Union of Concerned Scientists

June 20, 2008

Subject: NRC Special Inspection Report for RHRSW Valve Damage at Browns Ferry

Schematic diagram of one loop of the Residual Heat Removal system

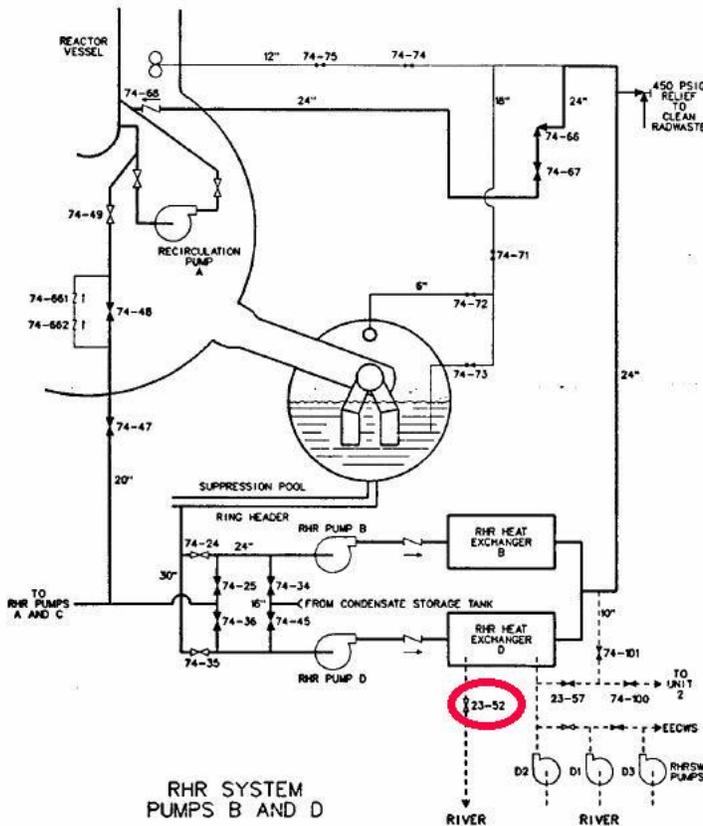
The valves in question are on the residual heat removal service water (RHRSW) outlet from the RHR heat exchangers. One such valve is circled in the graphic. Water from the RHR pumps flows through the RHR heat exchangers inside thousands of metal tubes. River water pumped by the RHRSW pumps enters the shells of the RHR heat exchangers and passes along the outside of the metal tubes. Heat flows through the tube walls to cool the RHR water and warm the RHRSW water. The subject valves open fully or partially to control the river water flow rate through the heat exchangers and close if one or more tubes break to prevent radioactively contaminated RHR water from reaching the river.
